Product/Process Change Notice (PCN)

PCN #: WE_WPCC_20150924
Product Affected: WE-WPCC 760308103202
PCN Date: October 8th 2015
Effective Date: October 8th 2015
Contact: Product Management
Phone: +49 (0) 7942 - 945 5001
Fax: +49 (0) 7942 - 945 5179
E-mail: pcn.eisos@we-online.de

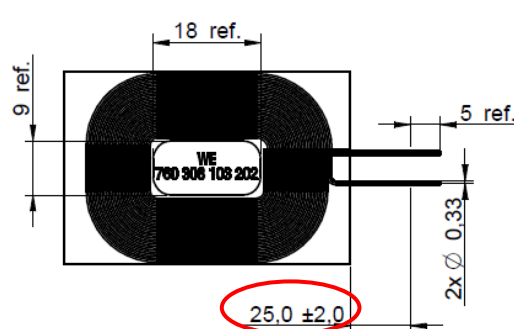
The lead length is changed from 10mm to 25mm. All receiver coils in the WPCC family will have the same lead length.
